Product Safety Bulletin No. 7

**Fasteners breaking on Grabber Cylinder**

All GDM 850 Ton Top Drives

Reference drawings A800345 and A800029

Measurement of the overall distance between the Grabber Torque Box Top (M800167) and Grabber Torque Box Bottom (M800128).

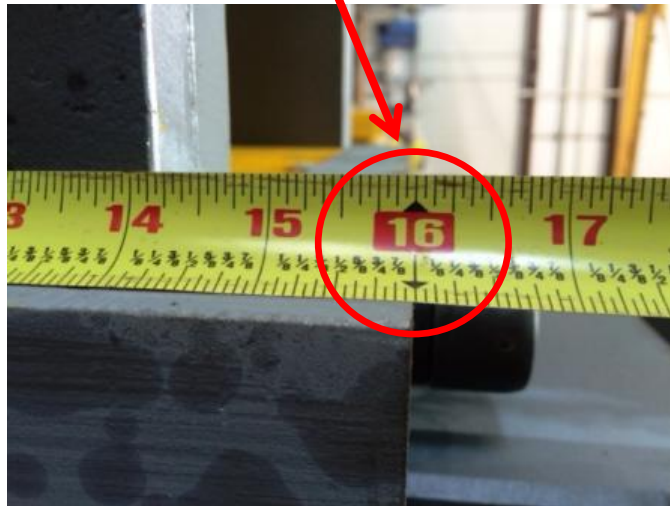
GDS received a recent report of a Near Miss involving the Grabber Die Block Pin (M500550) breaking and subsequently allowing the Die Block (M500585) to fall to the floor. Further inspection revealed that the bolts (026211.0632DH2) that retain the Grabber Cylinder Return Plate (M800025) to the piston (M800024) were broken as well.

Both of these breakages were due to the Grabber Assembly Torque Box Side Plates (M800130) being machined too thick and creating a gap between the Grabber Cylinder (M800546) and the Backup Wrench Weldment (M800113).

GDS recommends inspecting the two assemblies (A800345 and A800029) to insure the assembly has the proper height stack up. This is can be done by measuring the distance between the Grabber Assembly Torque Box Side Plates (M800130).The correct measurement is 16”

If there is a discrepancy, GDS recommends replacing the Grabber Assembly Torque Box Side Plates (M800130). If it is determined that more immediate repairs are required, please contact the GDS Service Department.
